4.26 TRAFFIC AND TRANSPORT

4.26.1 Predicted Road Traffic Impacts

Submission reference: RA7 and RA8

Figure 84
Key Road Midblock Capacity Diagram

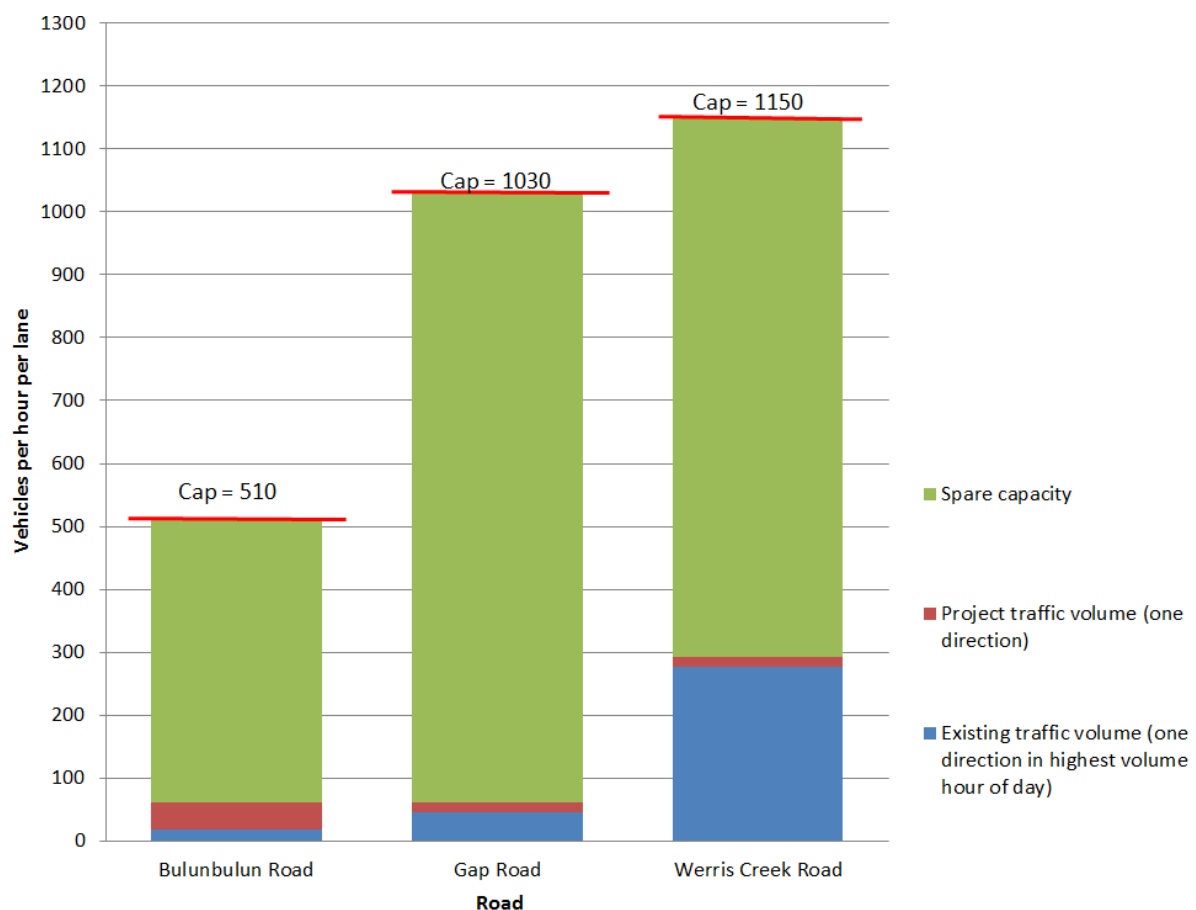
Figure 84 provides an indication of the maximum midblock capacity of Bulunbulun Road, Gap Road and Werris Creek Road. This figure also shows the existing traffic volumes and the additional traffic volumes that the Project will add. This is based on the detailed information and assessment provided below.

Figure 84 shows that the Project will only consume a relatively small portion of the available capacity in each of these three roads. As seen, the residual capacity is in the order of 440-970 vehicles/hour/lane. The Project traffic likely to use Bulunbulun Road, Gap Road and Werris Creek Road would consume 8.2%, 1.7% and 1.5% of the available capacity or less respectively.

FIGURE 85

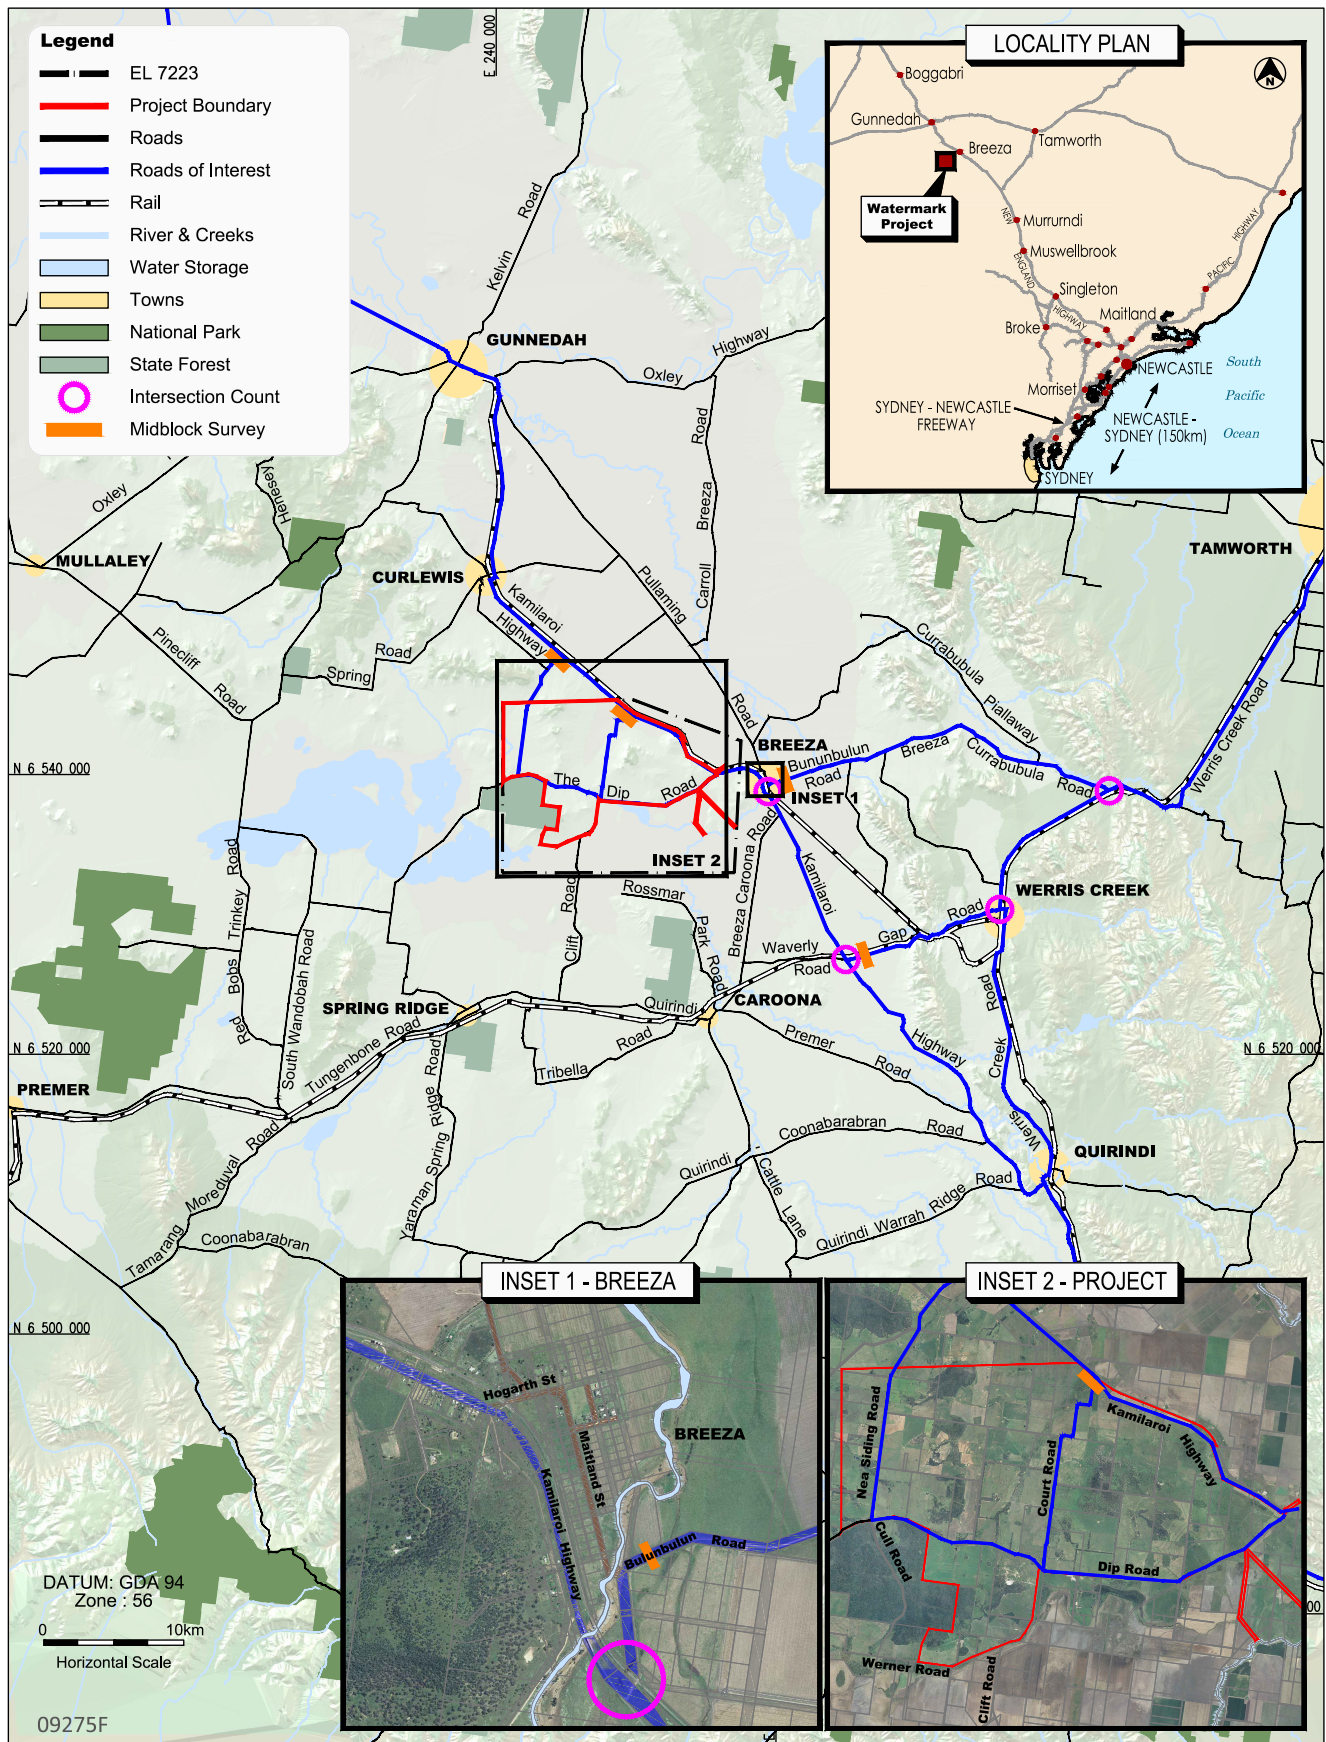
GSC has raised the concern that traffic travelling to and from the Project via Bulunbulun Road may attempt to take a short cut through the village of Breeza (see **Figure 85**).

To avoid additional traffic pressures on Breeza village and its road network, in particular Maitland Street and Hogarth Street, Shenhua Watermark is committed to ensuring that Project related traffic will be discouraged from using Hogarth Street to access Bulunbulun Road.

Figure 87
Key Intersections Capacity Diagram

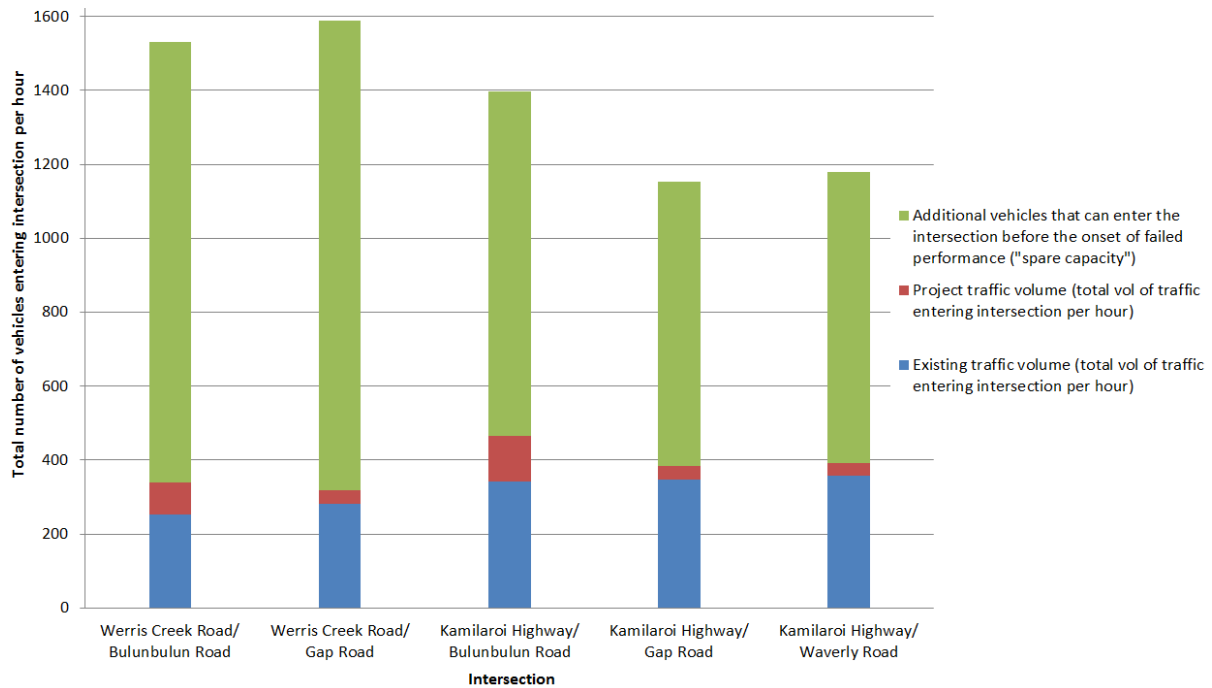
Figure 87 above provides the existing traffic volumes entering each of the five key intersections assessed (blue) as well as the likely increase in traffic volumes as a result of the Project (maroon). The green portion of each bar indicates the additional traffic that can enter each intersection until the onset of failed performance. In this case, the onset of failed performance was the boundary between Levels of Service (LoS) C and D, as a LoS of D is generally undesirable in regional road environments areas.

Figure 88
Peak Hour Volumes for Werris Creek Road/Bulunbulun Road Intersection

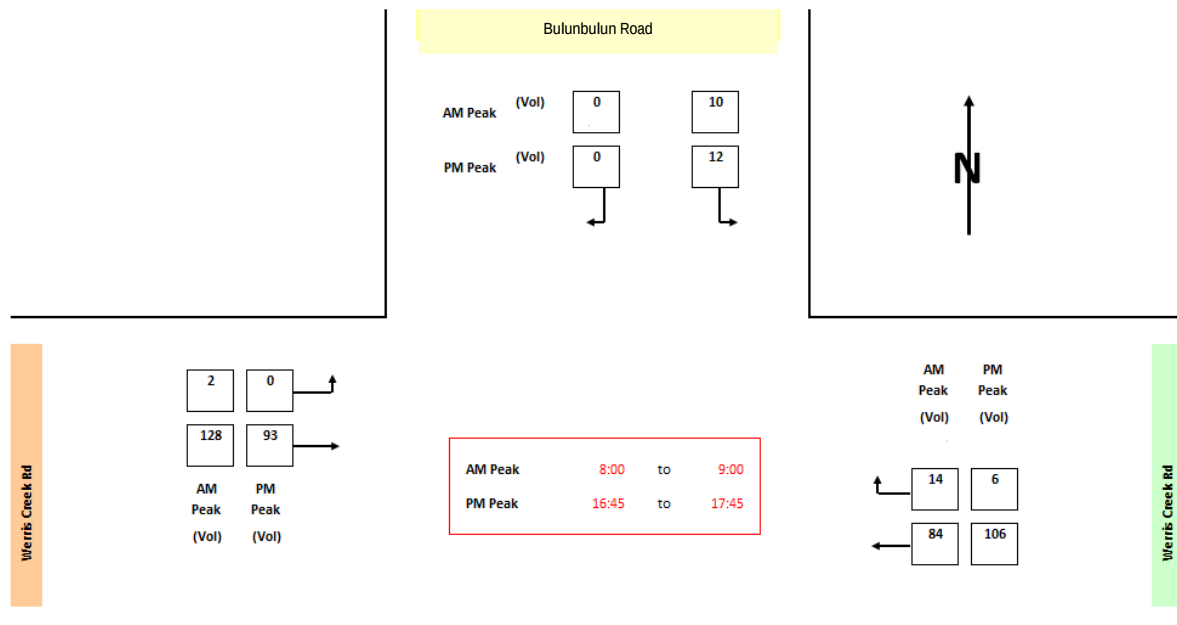
As discussed in **Section 4.26.1**, the Project is likely to generate 168 vehicle movements/day on Bulunbulun Road. This equates to 42 inbound vehicles and 42 outbound vehicles at each of the shift changes. Under the conservative assumption that the inbound and outbound volumes will coincide with each other, as well as with the AM peak period, 42 vehicles were added to the westbound right-turn movement from Werris Creek Road to Bulunbulun Road and 42 vehicles were added to the opposing left-turn from Bulunbulun Road. This is reflective of the likely journey to/from Tamworth. These volumes were added to the base case volumes (2013 background traffic) to determine the likely impact of Project-related traffic on this intersection (see **Table 74**).

The SIDRA modelling indicates that the additional traffic induced by the Project will have marginal impact on the intersection from a capacity perspective. This is reflected by the nil change to the LOS (A) and the minor increases to Degree of Saturation (DOS), average delay and maximum queue lengths. Therefore, the Project will not significantly alter the performance of this intersection.

Figure 89
Peak Hour Volumes for Werris Creek Road/Gap Road Intersection

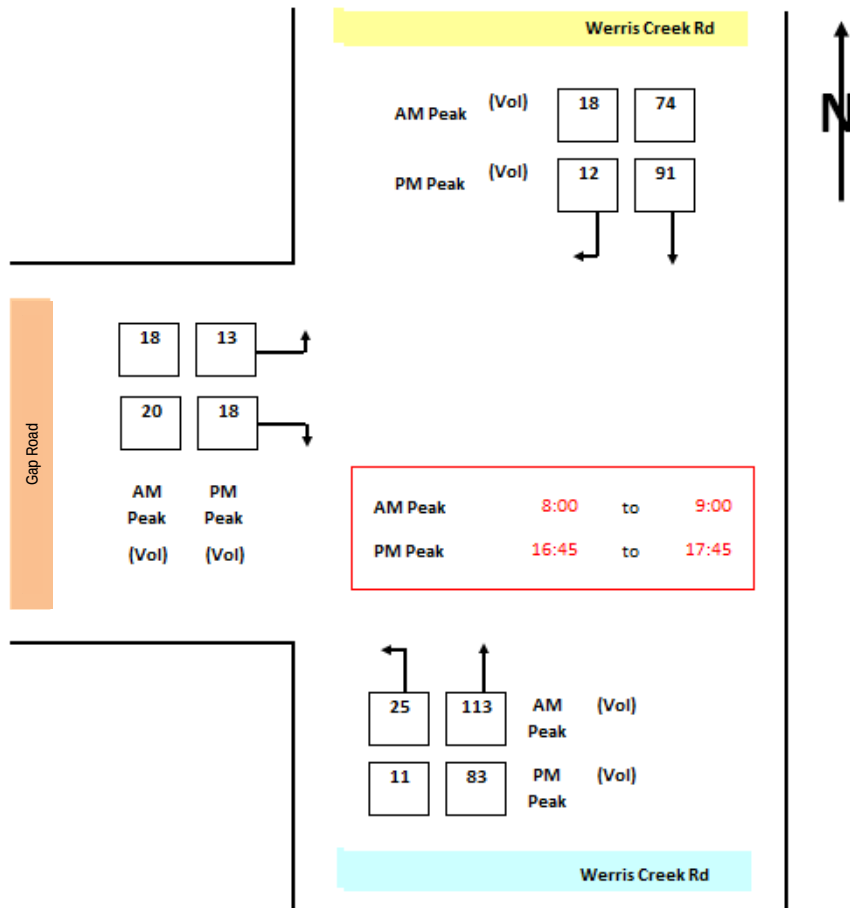
As described in **Section 4.26.1**, the Project is likely to generate 66 vehicle movements/day on Gap Road. This equates to 17 inbound and 17 outbound vehicles at each of the shift changes. Under a conservative assumption that the inbound and outbound volumes will coincide with each other, as well as with the AM peak period, 17 vehicles were added to the northbound left-turn movement from Werris Creek Road to Gap Road and 17 vehicles were added to the opposing right-turn from Gap Road.

The SIDRA modelling indicates that the additional traffic induced by the Project will have marginal impact on the intersection from a capacity perspective. This is reflected by the nil change to the LOS (A) and maximum queue lengths, and the minor increases to DOS and average delay. Therefore, the Project will not significantly alter the performance of this intersection.

Figure 90
Peak Hour Volumes for Kamilaroi Highway/Bulunbulun Road Intersection

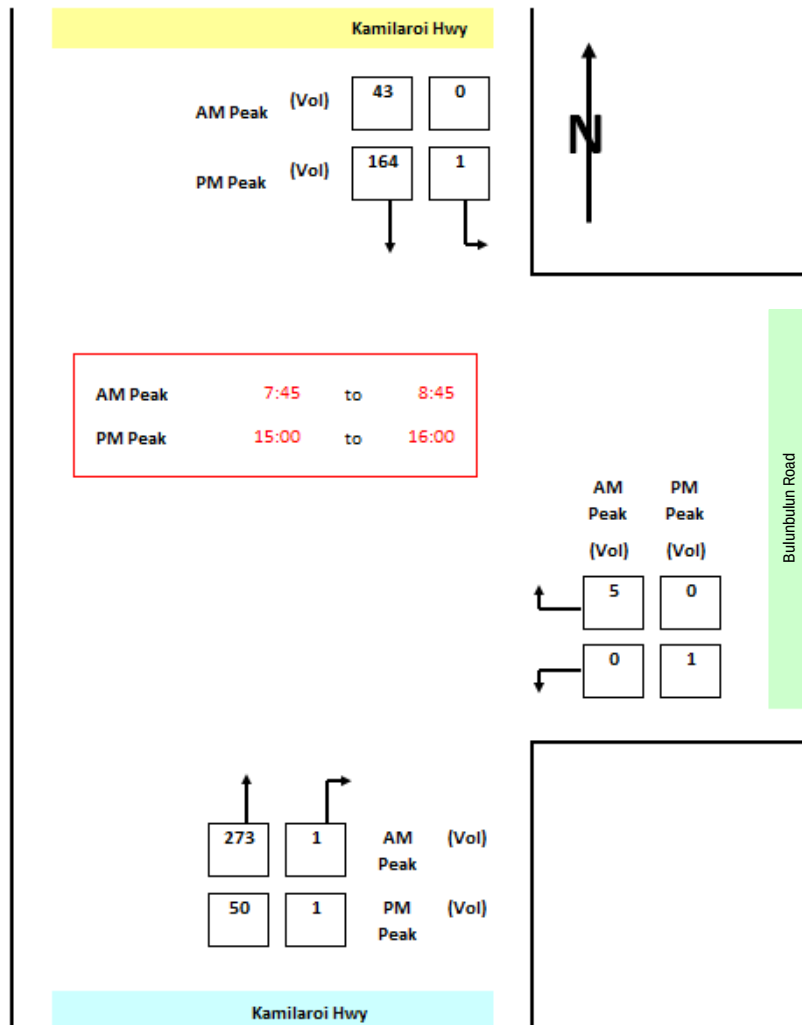
It has been conservatively assumed that the inbound and outbound vehicles would coincide, and that this Project-related traffic would also coincide with the AM and PM peak hours noted above. These volumes were added to the base case volumes (2013) to determine the likely impact of Project-related traffic on this intersection (see **Table 76**).

The SIDRA modelling indicates that the additional traffic induced by the Project will have marginal impact on the intersection from a capacity perspective. This is reflected by the nil change to the LOS (B), and the minor increases to DOS, average delay and maximum queue lengths. Therefore, the Project will not significantly alter the performance of this intersection.

Figure 91
Peak Hour Volumes for Kamilaroi Highway/Gap Road Intersection

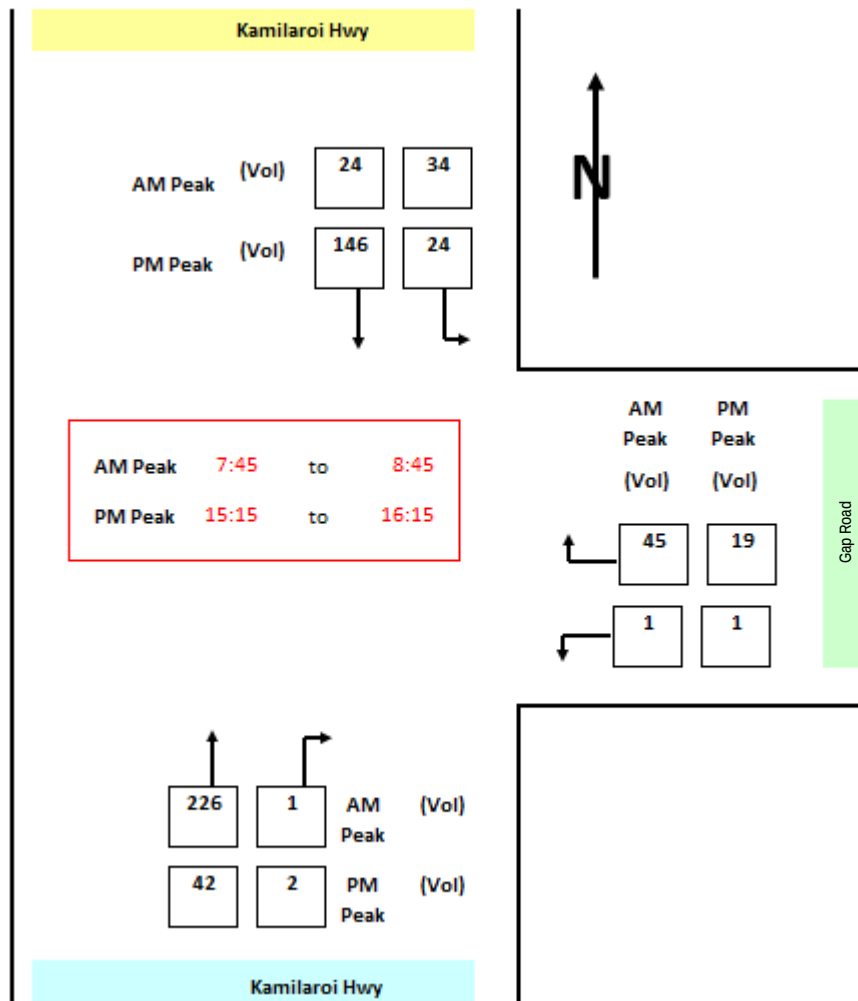
As described in **Section 4.26.1**, the Project is likely to generate 66 vehicle movements per day on Gap Road. Therefore, at the shift changes, there is likely to be 17 inbound and 17 outbound vehicles using Gap Road. It has been conservatively assumed that the inbound and outbound vehicles would coincide, and that this Project-related traffic would also coincide with the AM and PM peak hours noted above. Based on this traffic generation potential, 17 vehicles were added to the southbound left-turn movement from Kamilaroi Highway to Gap Road, and 17 vehicles were added to the opposing right-turn from Gap Road (see **Table 77**).

The SIDRA modelling indicates that the additional traffic induced by the Project will have marginal impact on the intersection from a capacity perspective. This is reflected by the nil change to the LOS (B) and DOS, and the minor increases to average delay and maximum queue lengths. Therefore, the Project will not significantly alter the performance of this intersection.

Figure 92
Peak Hour Volumes for Kamilaroi Highway/Waverly Road Intersection

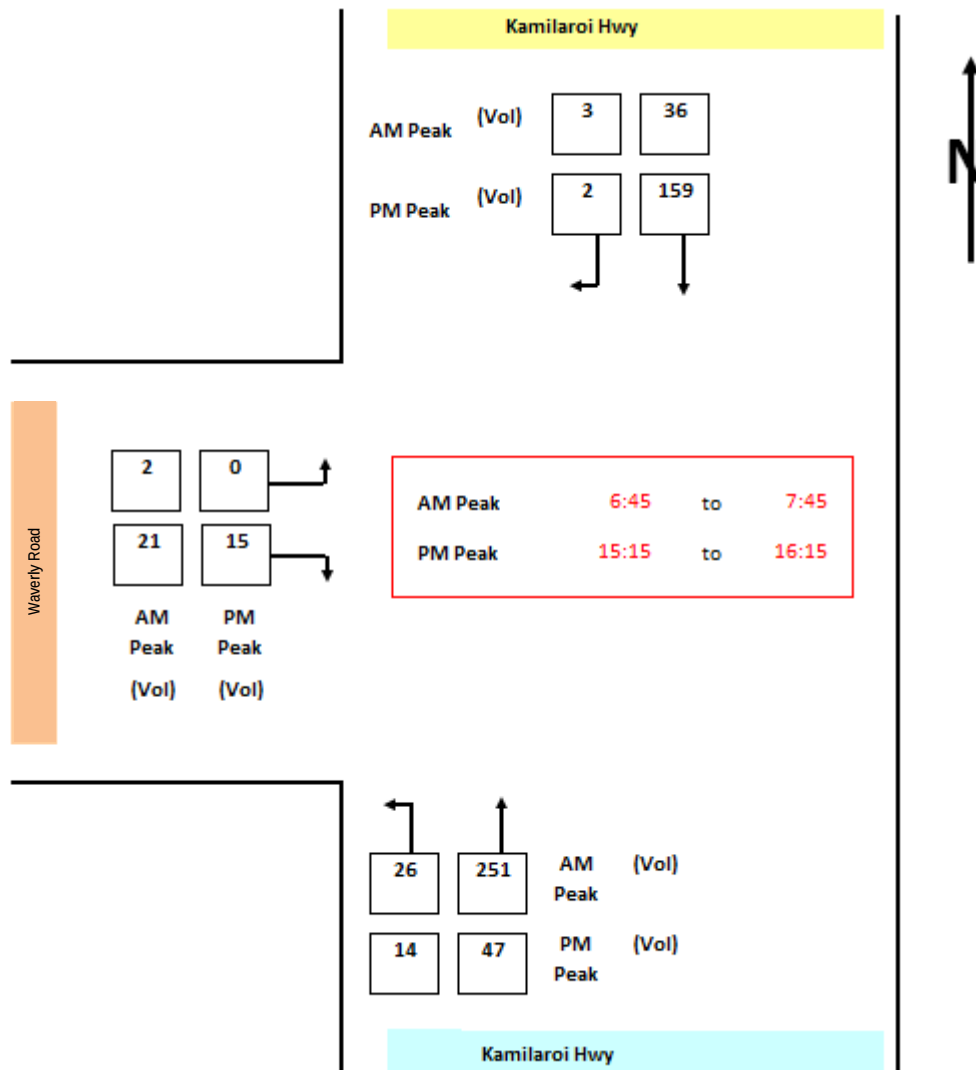
As described in **Section 4.26.1**, the Project is likely to generate 66 vehicle movements per day on Gap Road. Therefore, at the shift changes, there is likely to be 17 inbound and 17 outbound vehicles using Gap Road (and hence needing to pass through this intersection in the northbound and southbound through directions). It has been conservatively assumed that the inbound and outbound vehicles would coincide, and that this Project-related traffic would also coincide with the AM and PM peak hours noted above. Based on this traffic generation potential, 17 vehicles were added to the northbound through movement and 17 vehicles were added to the southbound through movement along the Kamilaroi Highway (see **Table 78**).

The SIDRA modelling indicates that the additional traffic induced by the Project will have marginal impact on the intersection from a capacity perspective. This is reflected by the nil change to the LOS (B) and average delay, and the minor increases to DOS and maximum queue lengths. Therefore, the Project will not significantly alter the performance of this intersection.
